## ARCHITECTURAL REVIEW BOARD STAFF REPORT

<b>Project #/Name</b>	SP-2025-03: Flow Honda/CDJR Outdoor Storage, Display, and Sales Expansion
<b>Review Type</b>	Advisory Review for a Special Use Permit
<b>Parcel Identification</b>	04500-00-00-068D4
<b>Location</b>	960 Seminole Trail
<b>Zoned</b>	Highway Commercial (HC) / Entrance Corridor (EC) / Airport Impact Area (AIA)
<b>Owner/Applicant</b>	Flow 960 Hilton LLC / Shimp Engineering (Julia Moore)
<b>Magisterial District</b>	Rio
<b>Proposal</b>	To amend an existing Special Use Permit (SP2002-46) to expand the outdoor storage/display/sales area located in front of the Flow Honda/CDJR building at 960 Seminole Trail.
<b>Context</b>	The Flow Honda/CDJR site is located in the heavily developed Rt. 29 commercial corridor. The Honda/CDJR building is located just north of the Flow Subaru (previously Umansky) building. A Walmart is situated to the south across Hilton Heights Rd. Just beyond Walmart is the Malloy Chevrolet auto dealership. To the west is Sam's Club, and a DoubleTree hotel is located to the north. A variety of commercial buildings stand on the opposite side of Rt. 29. (Fig. 1.)

# FLOW HONDA/CDJR CONCEPT PLAN

**Figure 2:** Proposed concept plan identifying new vehicle display areas, existing display areas that are to be converted to parking, and existing parking that is to remain.

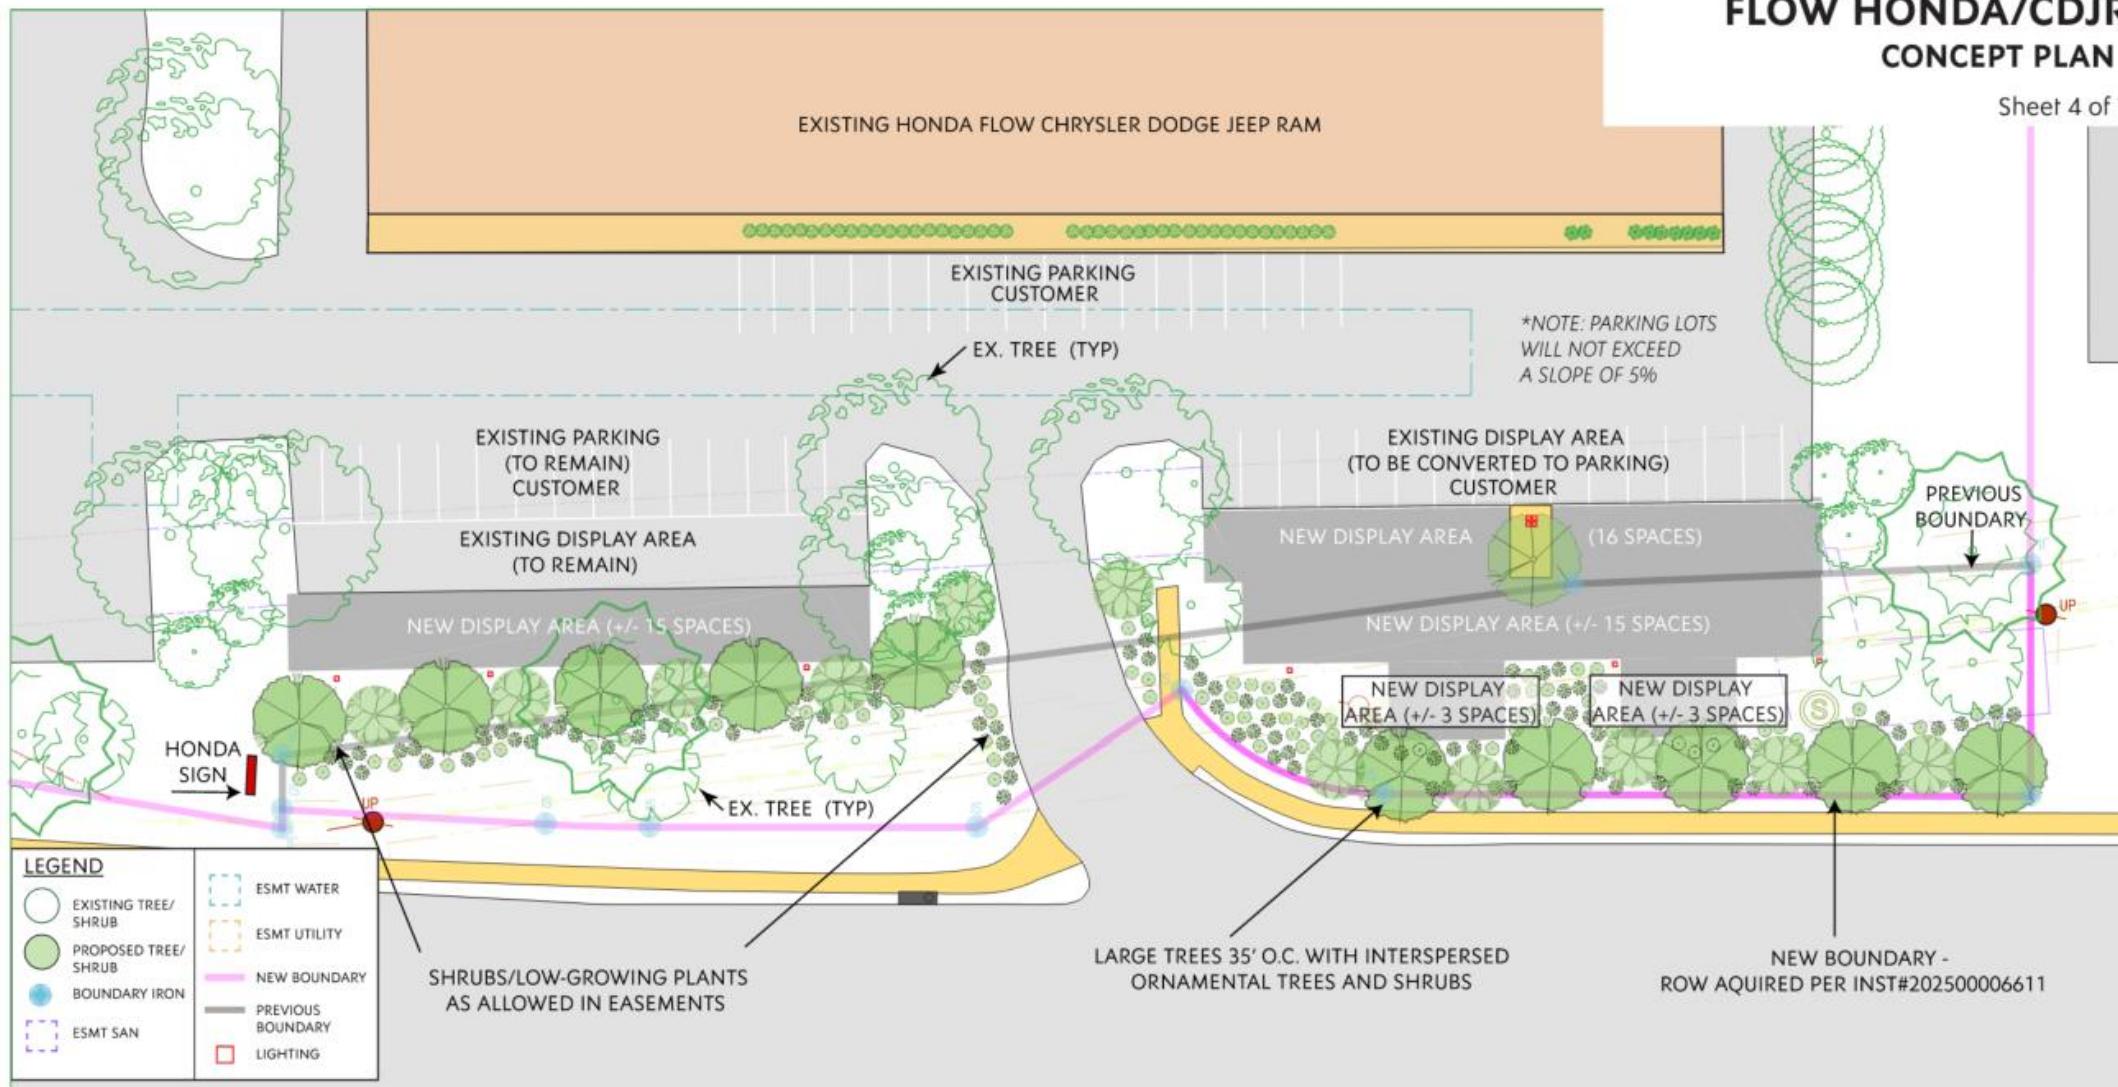
8	Continuity within the Entrance Corridor should be obtained by planting different types of plant materials that share similar characteristics. Such common elements allow for more flexibility in the design of structures because common landscape features will help to harmonize the appearance of development as seen from the street upon which the Corridor is centered.	The current paved area measures between 73 and 78 feet from the edge of the pavement. The proposed concept plan shows that the display parking area will be expanded by approximately 8,355 square feet. This will be done by converting a portion of the existing landscaped area along the frontage into paved parking, which will include triple-stacked parking arrangements on both the northern and southern sides of the right-in entrance. North of the entrance, the proposed display extends towards the EC with two paved "bumpouts" accommodating approximately 6 additional vehicles. This brings the display parking within 25' of the edge of pavement. The existing display spaces north of the entrance will be converted to customer parking.

32	<p>Landscaping along the frontage of Entrance Corridor streets should include the following:</p> <p>a. Large shade trees should be planted parallel to the Entrance Corridor Street. Such trees should be at least 3½ inches caliper (measured 6 inches above the ground) and should be of a plant species common to the area. Such trees should be located at least every 35 feet on center.</p> <p>b. Flowering ornamental trees of a species common to the area should be interspersed among the trees required by the preceding paragraph. The ornamental trees need not alternate one for one with the large shade trees. They may be planted among the large shade trees in a less regular spacing pattern.</p> <p>c. In situations where appropriate, a three or four-board fence or low stone wall, typical of the area, should align the frontage of the Entrance Corridor street.</p> <p>d. An area of sufficient width to accommodate the foregoing plantings and fencing should be reserved parallel to the Entrance Corridor street, and exclusive of road right-of-way and utility easements.</p>	<p>Conceptual landscaping is included on the concept plan. The area subject to the special use permit (see sheet 7 of Attachment 2) has approximately 355' of frontage along the EC and utilities – both underground and overhead – are in place along the frontage, further limiting the available planting area. The concept plan shows large shade trees with ornamental trees and shrubs interspersed behind the overhead line (labeled in yellow) south of the right-in entrance and in front of the overhead line north of this entrance. The proposed large trees south of the entrance seem to conflict with existing trees designated to remain. Additionally, the arrangement of shrubs along the southern edge of the entrance and in the planting area to the north appears random and uncoordinated. While this layout generally satisfies the frontage planting requirements and is expected to mitigate the visual impact of the expansion of paved area on the EC, it requires better coordination with the</p>

<p>existing landscaping and more refinement of the arrangement of proposed landscaping.</p> <p>The layout shown in the concept plan provides sufficient planting area to avoid conflicts with existing utilities.</p>	
33	<p>Landscaping along interior roads:</p> <p>a. Large trees should be planted parallel to all interior roads. Such trees should be at least 2½ inches caliper (measured six inches above the ground) and should be of a plant species common to the area. Such trees should be located at least every 40 feet on center.</p>	<p>There are no existing or proposed interior roads within this site.</p>	None.
35	<p>Landscaping of parking areas:</p> <p>a. Large trees should align the perimeter of parking areas, located 40 feet on center. Trees should be planted in the interior of parking areas at the rate of one tree for every 10 parking spaces provided and should be evenly distributed throughout the interior of the parking area.</p> <p>b. Trees required by the preceding paragraph should measure 2½ inches caliper (measured six inches above the ground); should be evenly spaced; and should be of a species common to the area. Such trees should be planted in planters or medians sufficiently large to maintain the health of the tree and shall be protected by curbing.</p> <p>c. Shrubs should be provided as necessary to minimize the parking area's impact on Entrance Corridor streets. Shrubs should measure 24 inches in height.</p>	<p>There are existing trees that are to remain along the northern perimeter of the site that meet the perimeter parking area requirements.</p> <p>The proposal does not appear to meet the requirement for interior parking trees. Approximately 52 new parking spaces are proposed, requiring an additional 5 trees, but only one interior tree has been added. The trees located north and south of the right-in entrance, as well as those along the northern perimeter of the site, compensate for the absence of interior trees in the expanded paved area. Additionally, the arrangement of trees and shrubs along the front of the site is expected to effectively filter the view of the additional display spaces, reducing the necessity for trees within the paved area itself.</p>	None.

changes are proposed. Reducing the boundaries to only include the area where changes are proposed would be appropriate.	
	<b>Site Grading</b>		
40	Site grading should maintain the basic relationship of the site to surrounding conditions by limiting the use of retaining walls and by shaping the terrain through the use of smooth, rounded landforms that blend with the existing terrain. Steep-cut or fill sections are generally unacceptable. Proposed contours on the grading plan shall be rounded with a ten-foot minimum radius where they meet the adjacent condition. Final grading should achieve a natural, rather than engineered, appearance. Retaining walls 6 feet in height and taller, when necessary, shall be terraced and planted to blend with the landscape.	There is a gentle change in topography between the showroom building and the EC. Grading is shown to establish the expanded display area; however, this grading is minimal and is not expected to have a negative visual impact on the EC. The slope of the new planting area shown on the site section (Sheet 6 of Attachment 2) appears to be exaggerated.	Revise the site section in the concept plan to show a more accurate representation of the proposed grading.

1. Revise the site section in the concept plan to show a more accurate representation of the proposed grading.
2. Revise the concept plan to note the correct SP number (SP-2002-46) that is being amended.

3. Revise the concept plan to note the correct SP number (SP-2025-03) under review.
4. Revise the boundaries of the proposed amendment area shown on sheets 6 and 7 of the concept plan to include only the area where changes are proposed.
